(65.0' - 65.0') PRESTRESSED CONCRETE SPREAD BOX BEAM SPANS

BRIDGE NO.
A9552

| DATE | DESCRIPTION |
|----------|------------------------------------|
| 01/28/26 | REV. 1 - NDC-055 - REVISED NOTE |

| DATE | DESCRIPTION |
|----------|------------------------------------|
| 01/28/26 | REV. 1 - NDC-055 - DELETED NOTE |

Note: This drawing is not to scale. Follow dimensions. Sheet No. 1 of 39

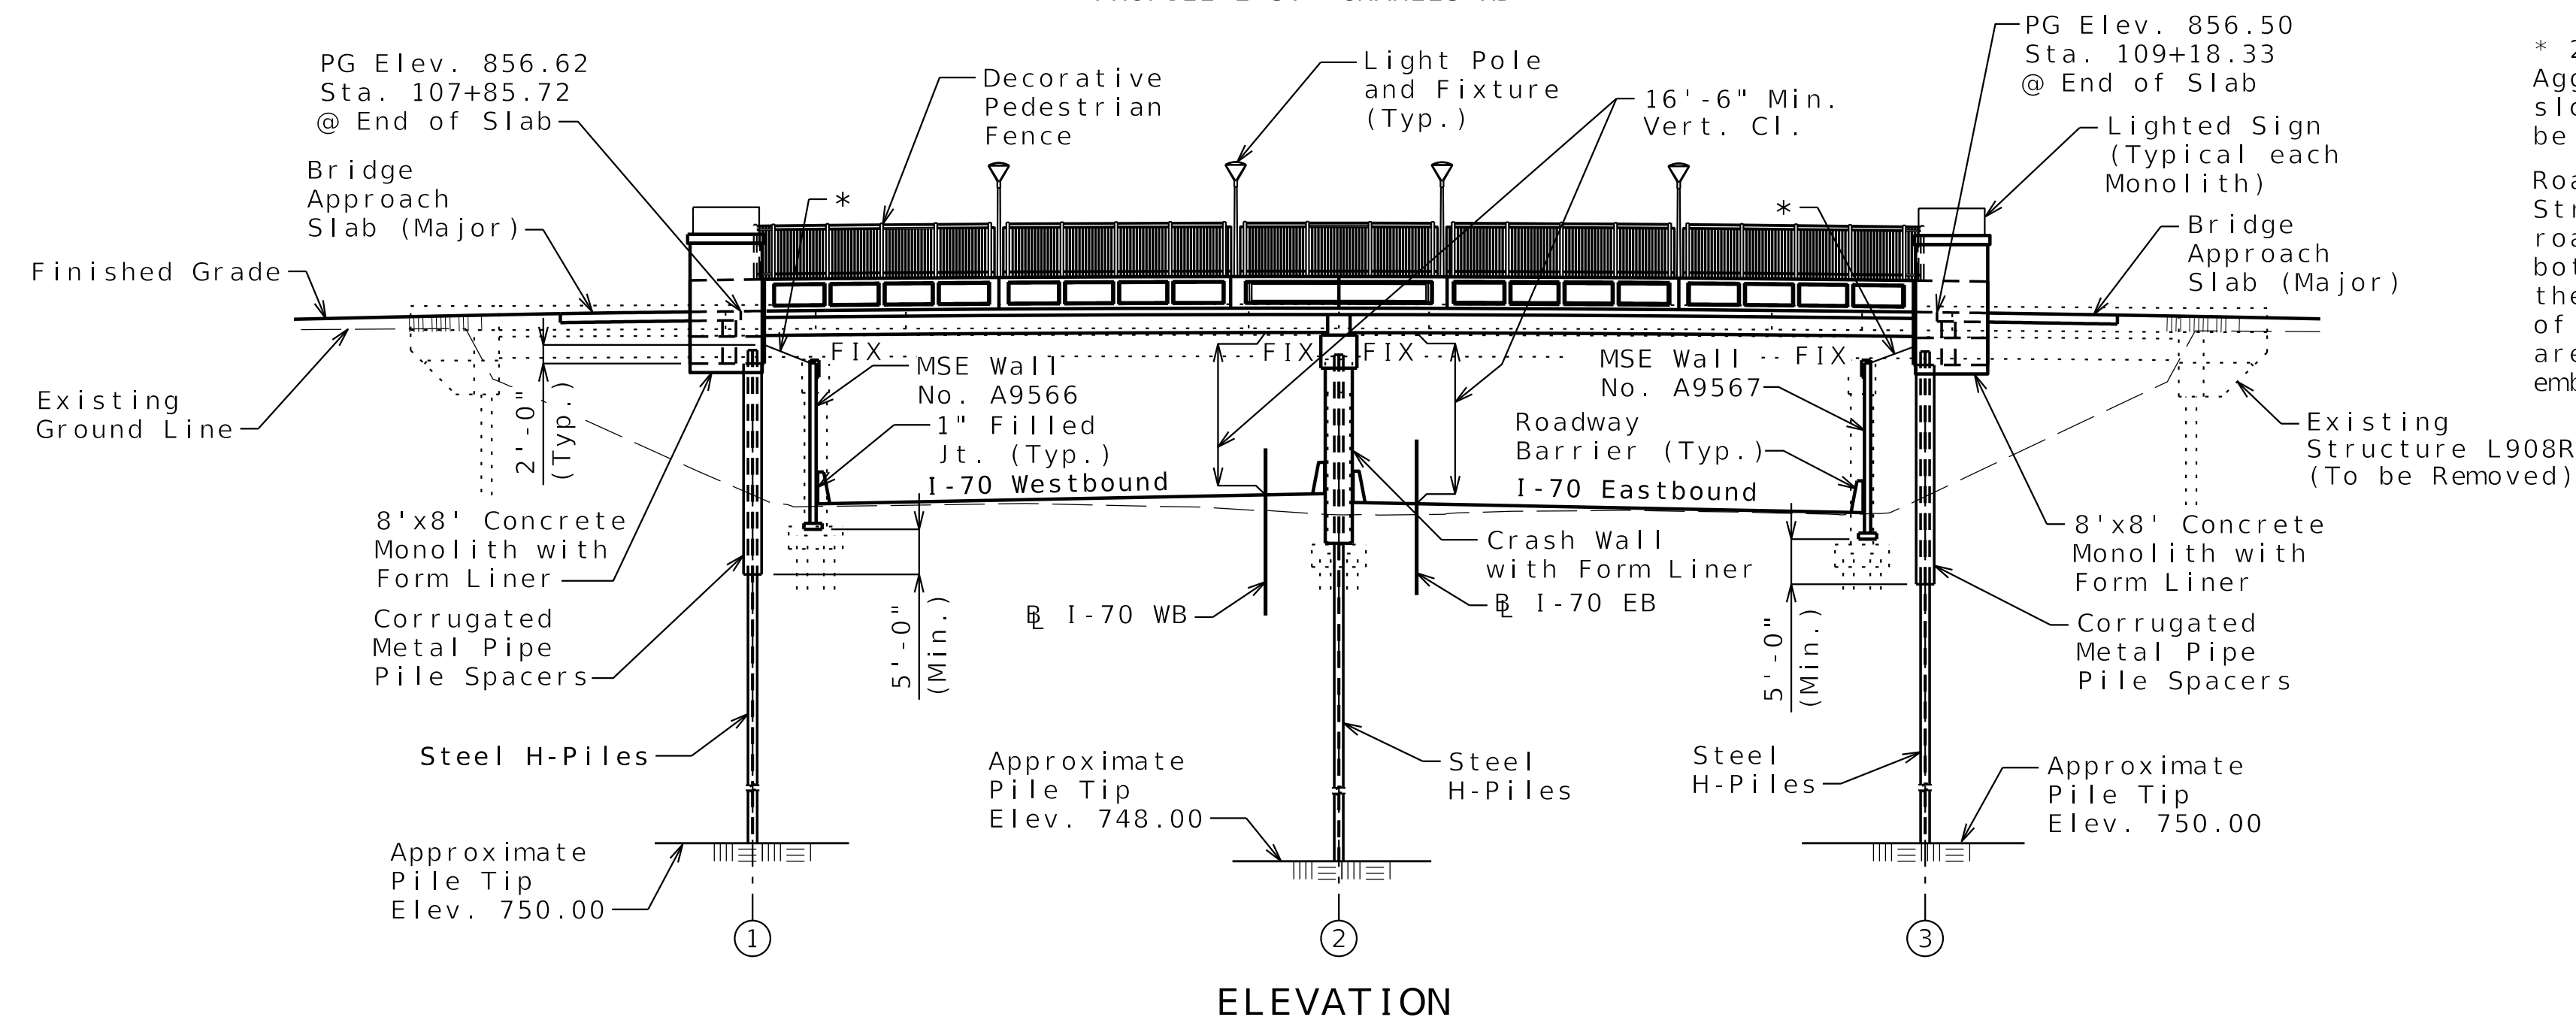
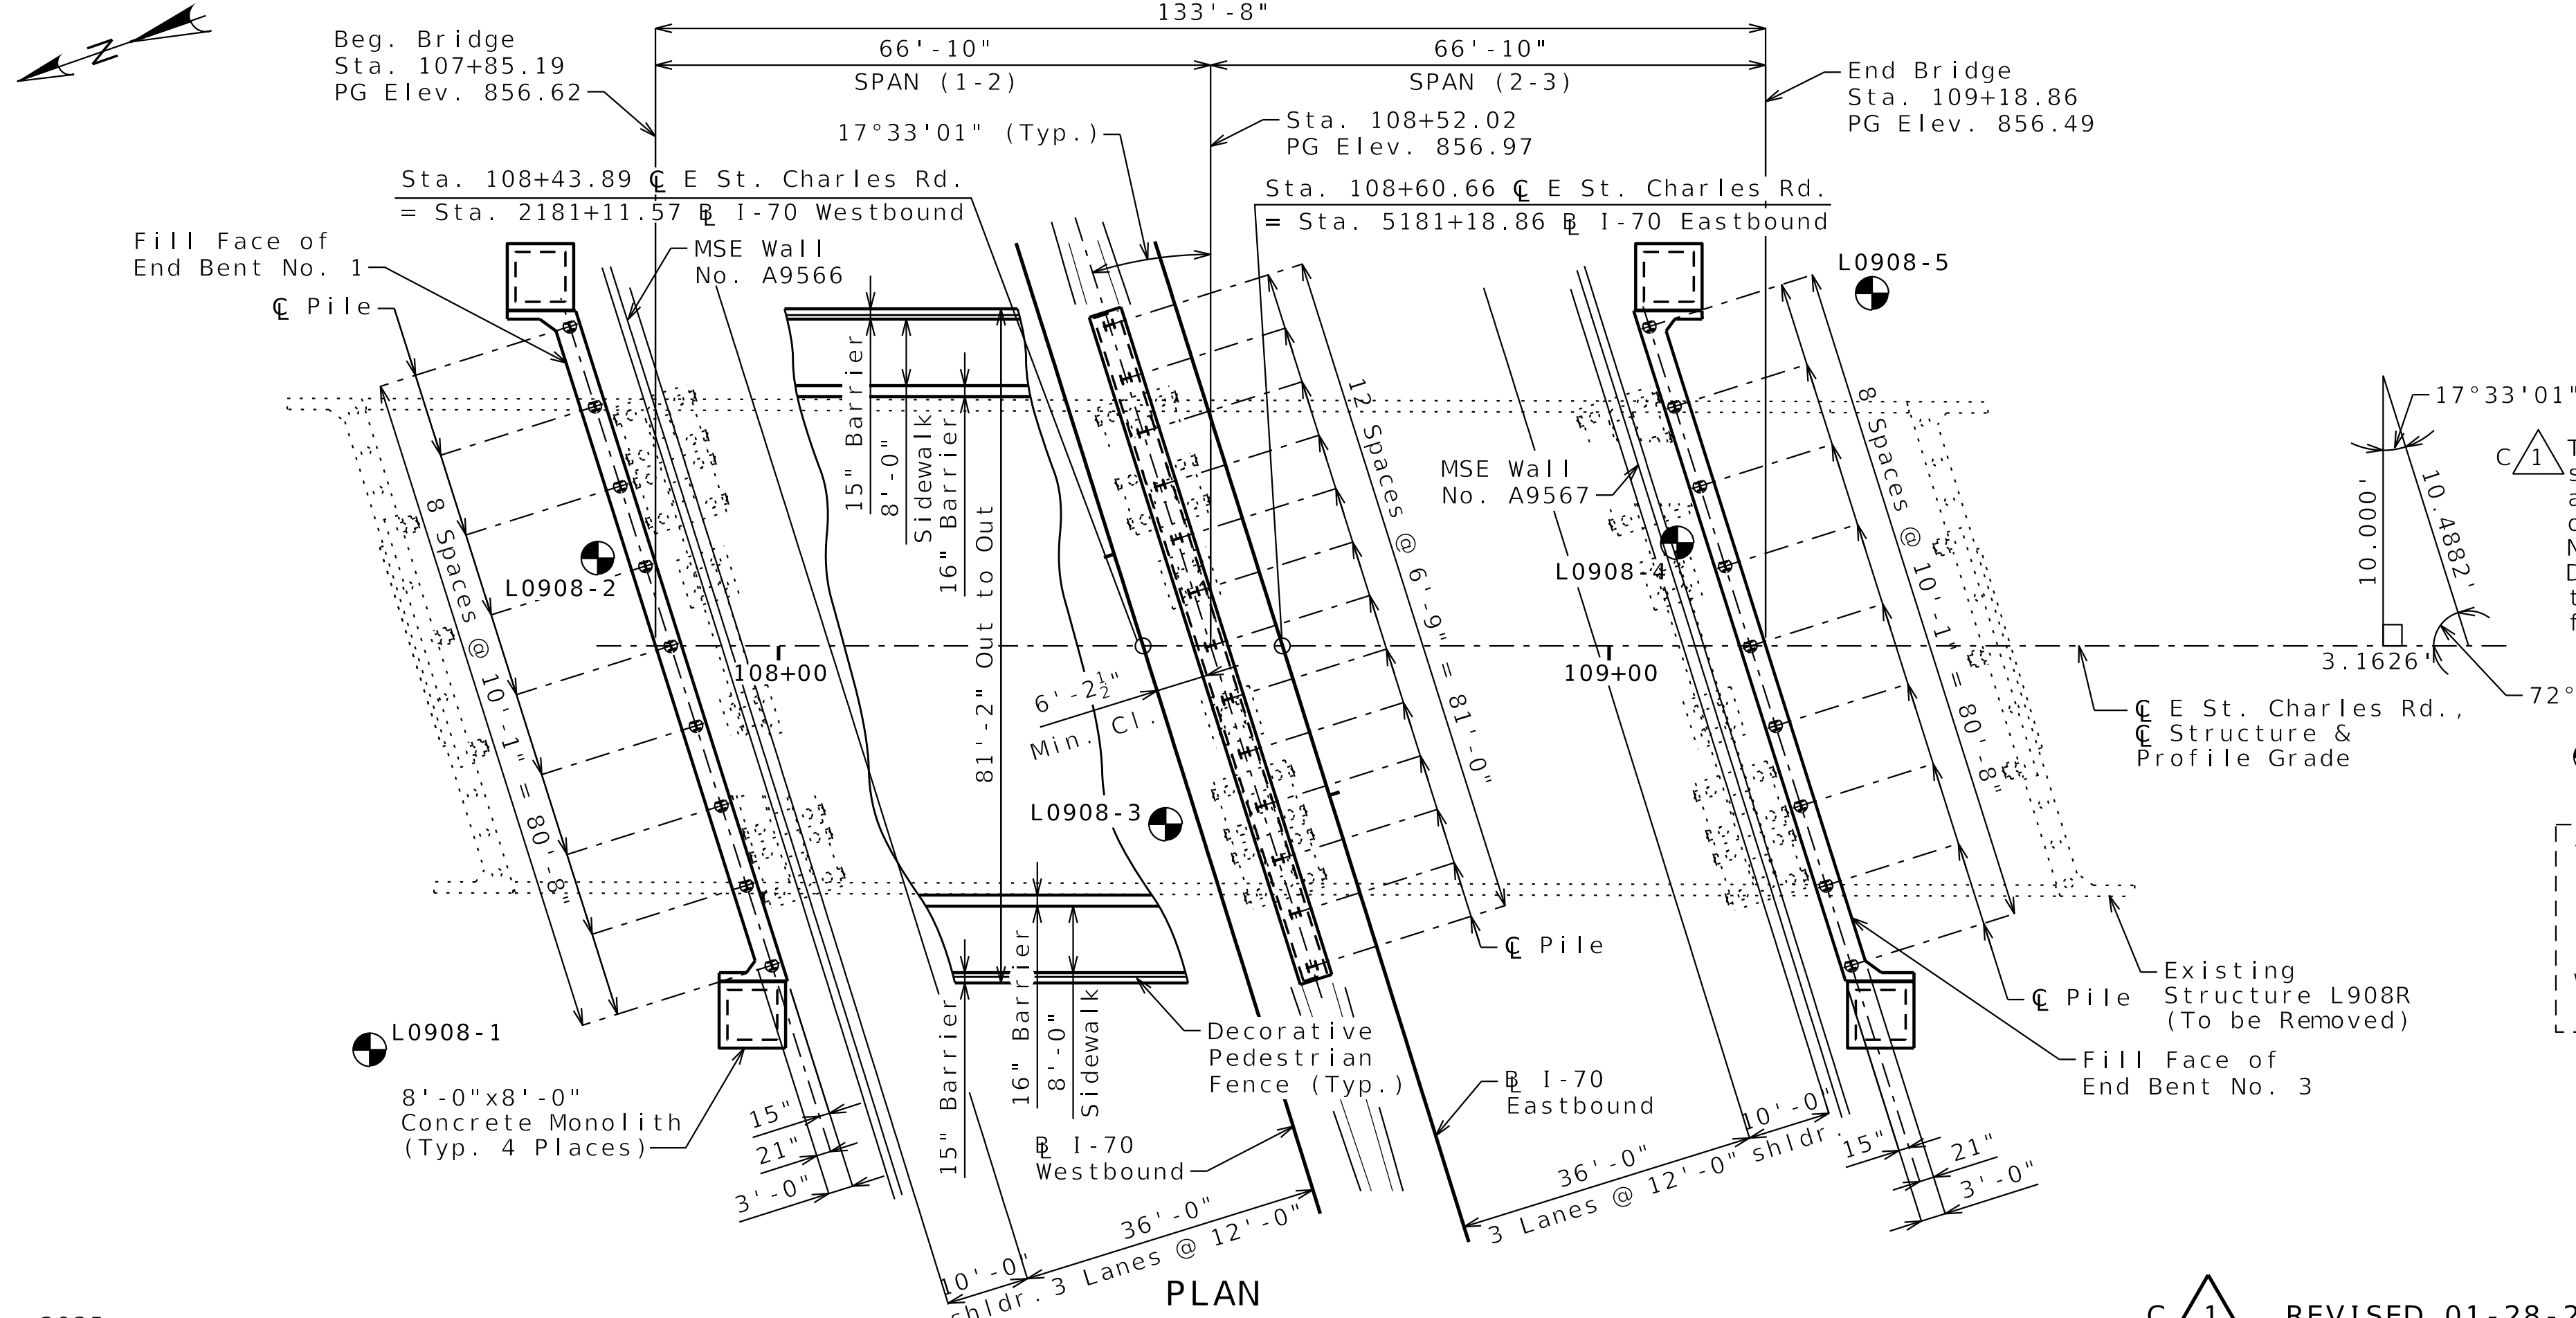
REVISED 01-28-26

LOCATION SKETCH

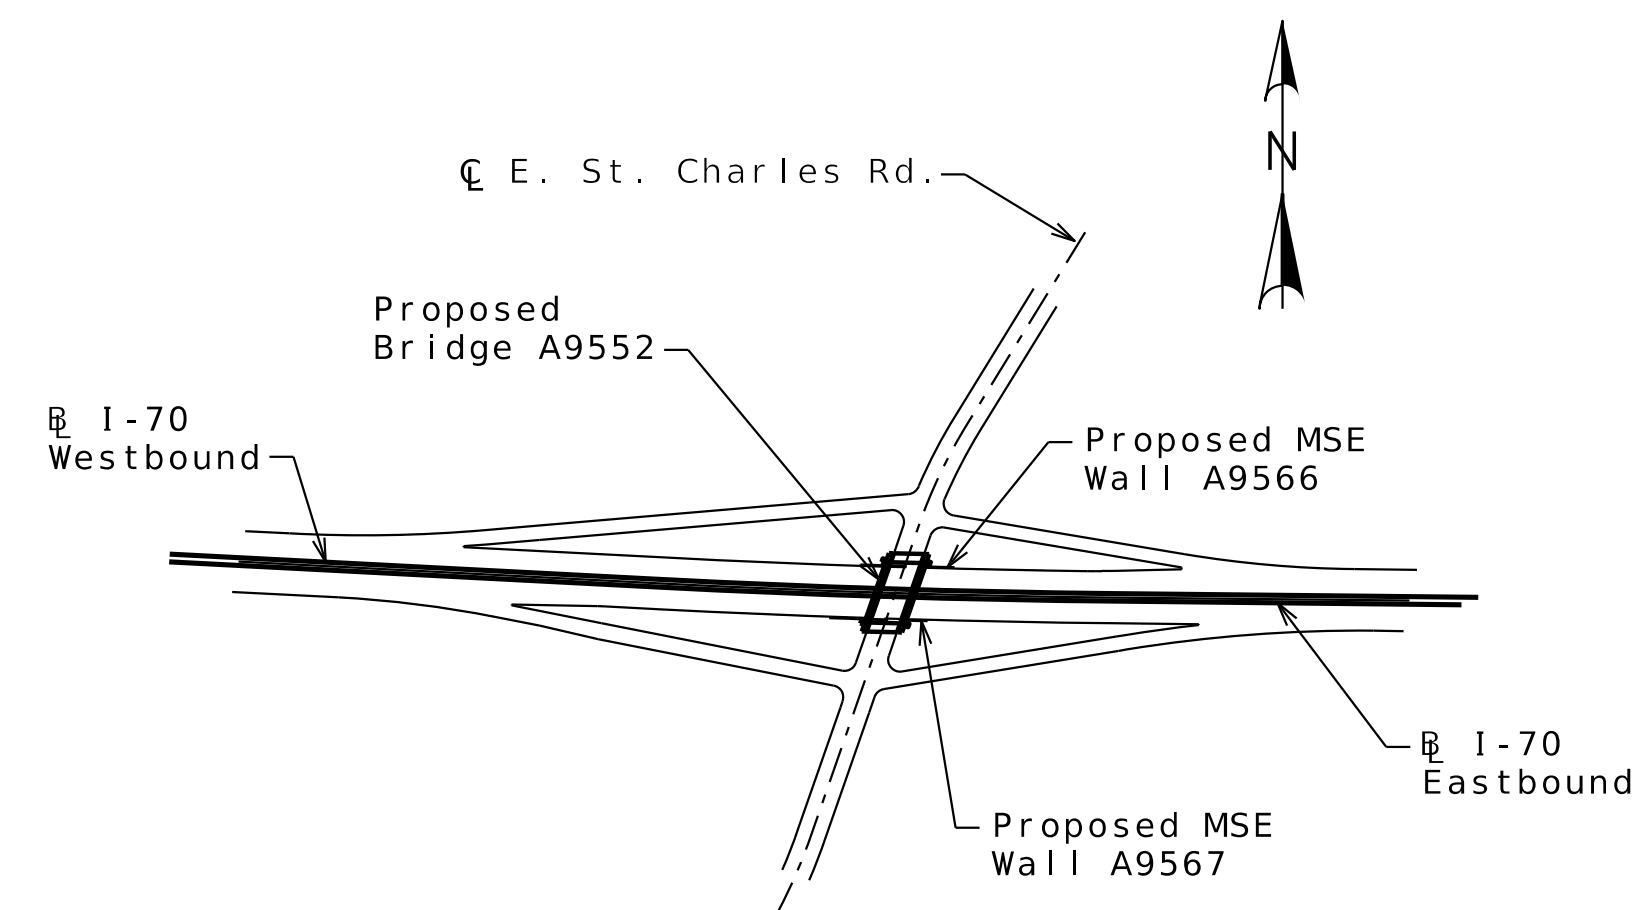
~~All piles shall be galvanized full length.~~ ← C 1 DELETED
